September 19, 2011

**Subject: Comment Letter, Caltrans MS4 Permit**

Caltrans comments on the <u>Revised Draft Tentative Order</u> (NPDES Permit No. CAS000003), dated August 18, 2011, for the State of California, Department of Transportation

**85.** "Defined standard" – One of the line reporting items for Field Non-Compliance is:

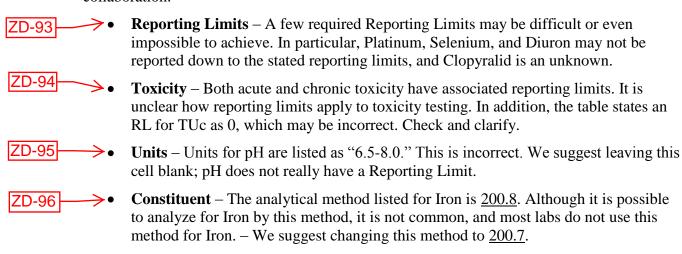
ZD-91 Comment – The Glossary contains no definition of "defined standard" or "standard." Generally, standard in the context of NPDES permits refers to State adopted "water quality standards" (WQS) approved by USEPA and established pursuant to requirements in the Clean Water Act. "Defined standard" as described above appear to be a subset of WQS, but additionally include waste load allocations (WLA), which may be included in Basin Plans but may not be WQS because they are neither criteria (objectives in California) nor beneficial uses. Clarify.
